CITY OF WESTFIELD, IN
Advisory Planning Commission Meeting Agenda 07_20_2015

MEETING DATE: Monday, July 20, 2015 at 07:00 PM

1507-ODP-18 & 1507-SPP-18

Lantern Park

Date:	07-10-15
Project No:	07053
Sheet No:	C100

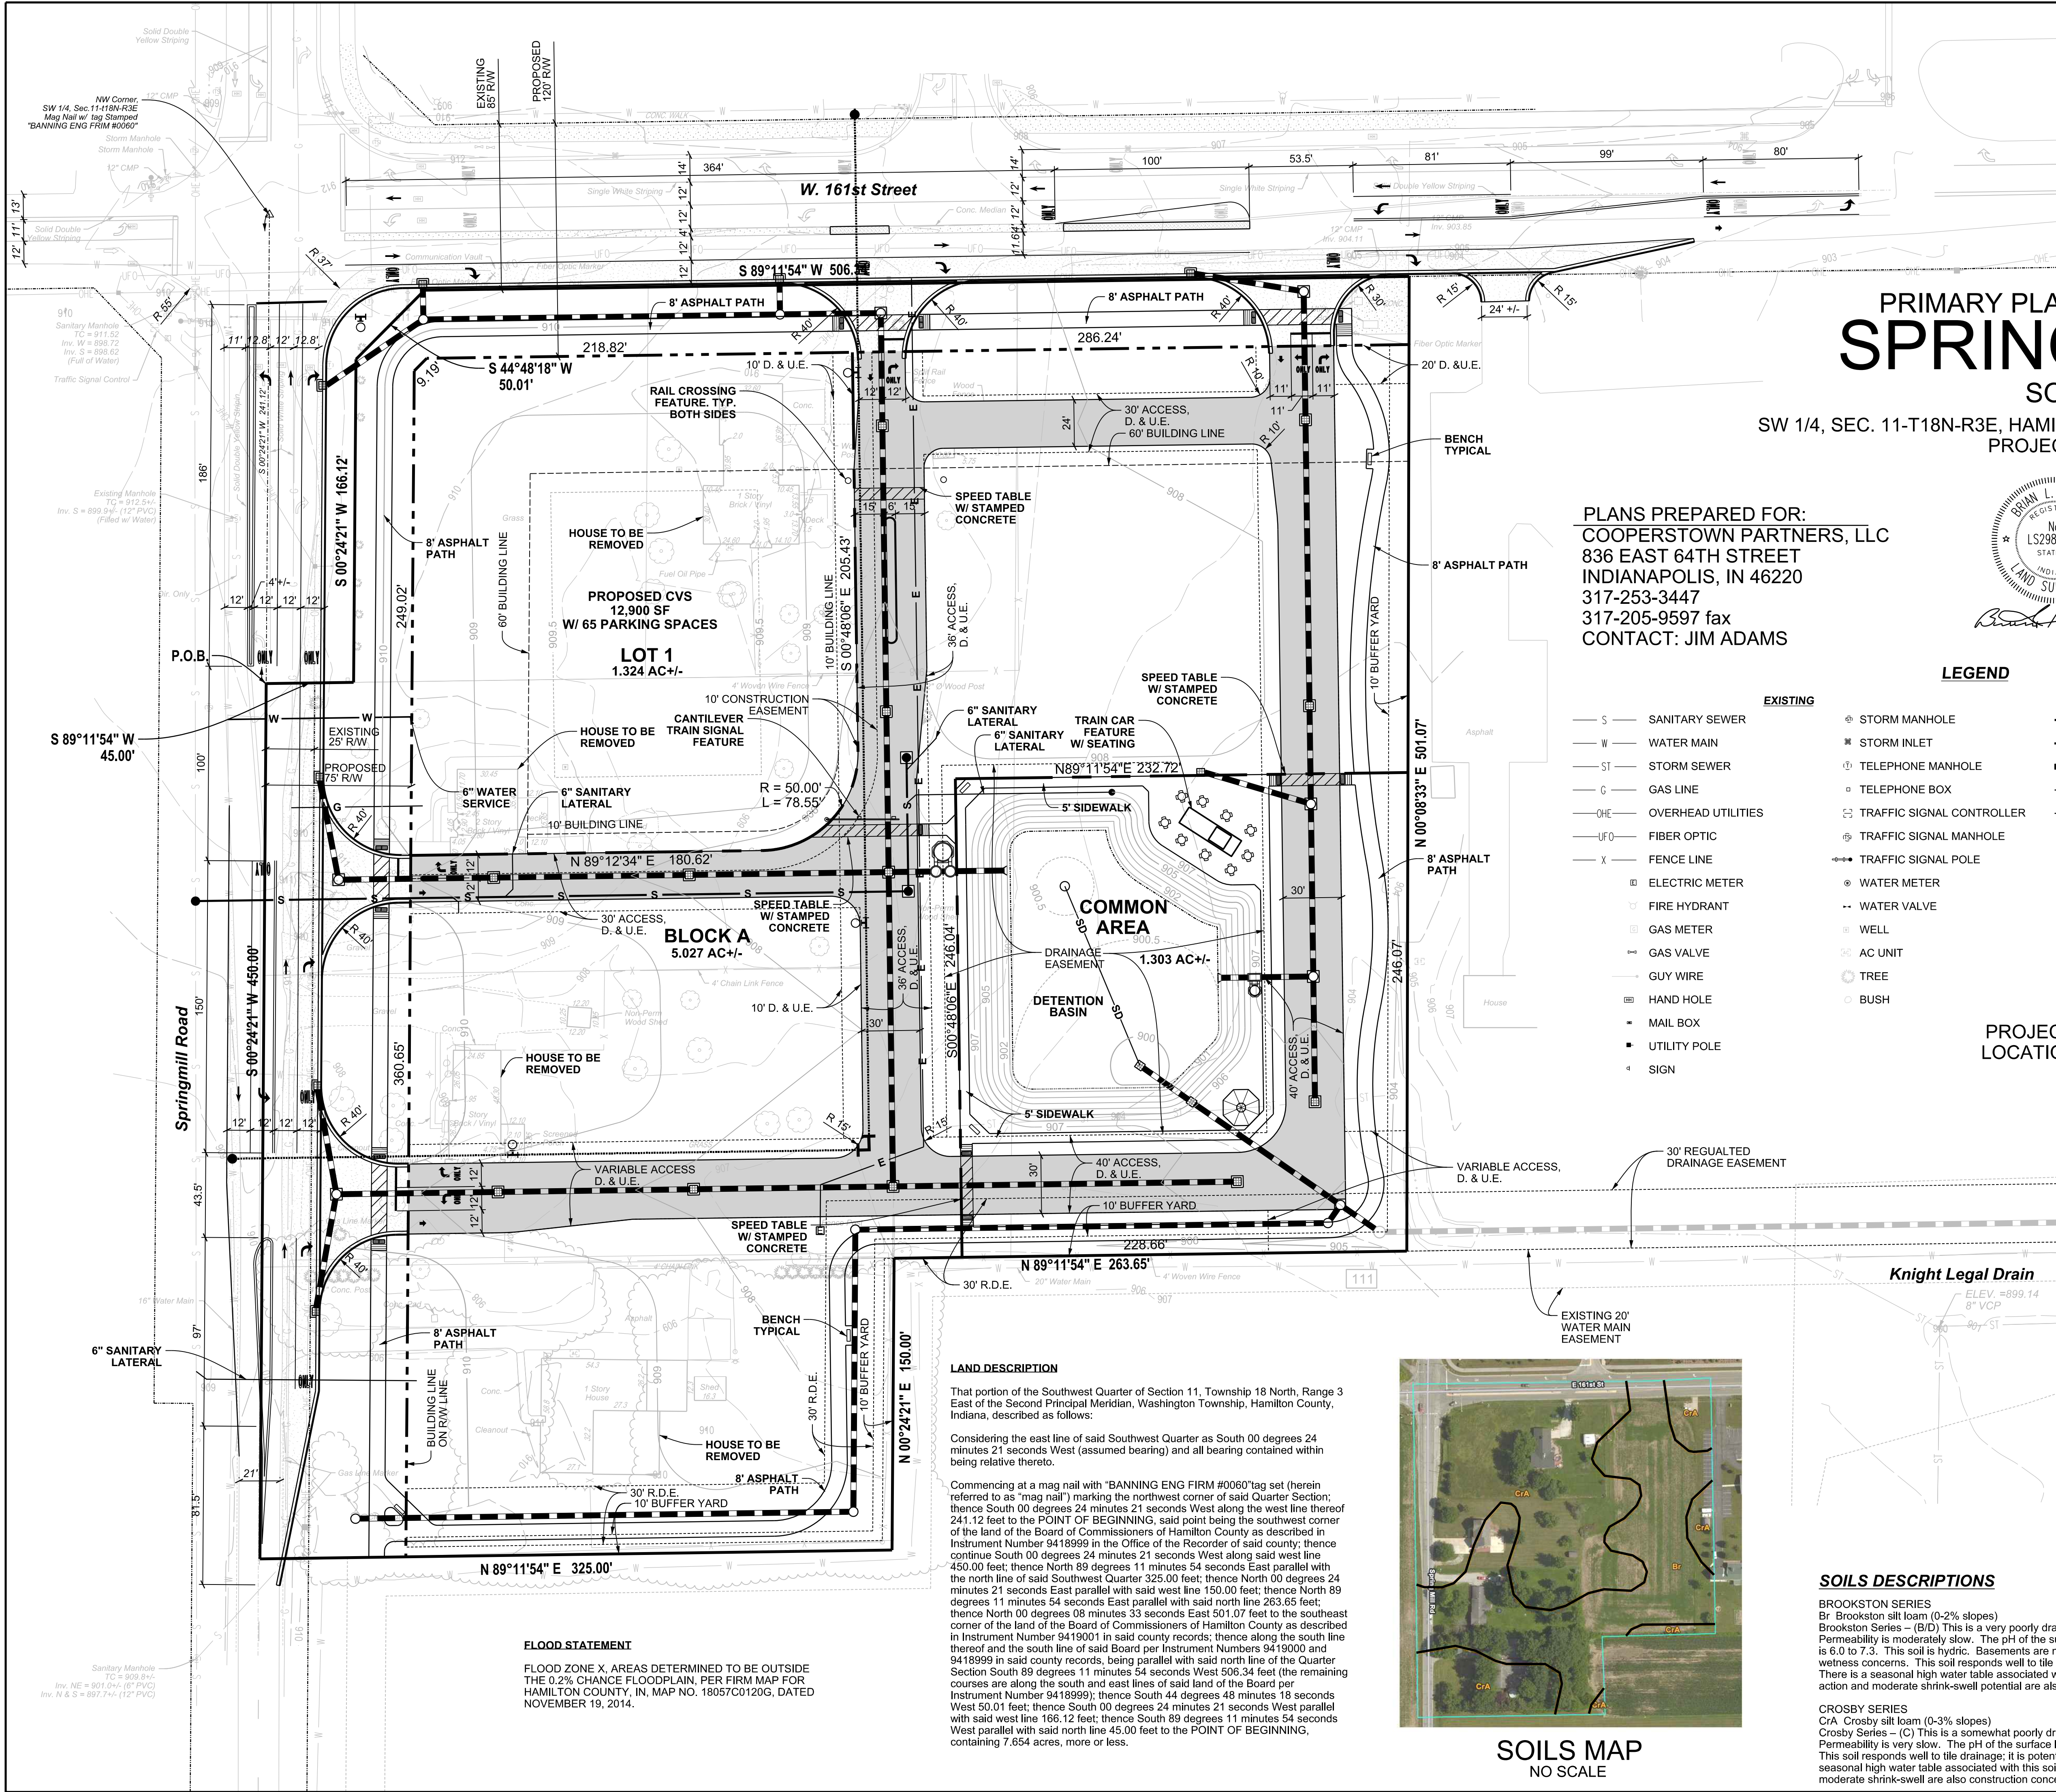
There is a chance that I may not attend today's meeting hence the reason for this email. You will be deciding on the Spring Mill Station SE corner – 161st and Spring Mill Road. When looking at Exhibit 3: Primary Plat and Overall Development Plan, I have a concern about the two right-in, right out (RIRO) access drives of this project. I believe this intersection and it's four corners will become important and instrumental to the future growth to the near west side of Westfield. Development will come.

When checking the Westfield Washington Comprehensive Plan in Chapter 2, page 16, is a graphic about regulating minimum driveway separation in regards to arterial roadways. In the Comp Plan, it states: Maximum of one driveway for lots less than 600 feet wide. Also the minimum is 250 feet between drives. Page 16 is attached to this email. It appears the plan for this project does not adhere to the Westfield Washington Comprehensive Plan.

Is it possible to delete the right-in, right-out drives? These right-in, right-out drives interior of the development will cause additional traffic conflict points. One has to look just across the street to the north to see multiple conflict points between the Chase Bank and Pizza Hut. I ask that you request the petitioner to reconsider the use of the RIRO drives so close to the Spring Mill/161st intersection. I believe their plan will work (and better) without them. Thank you.
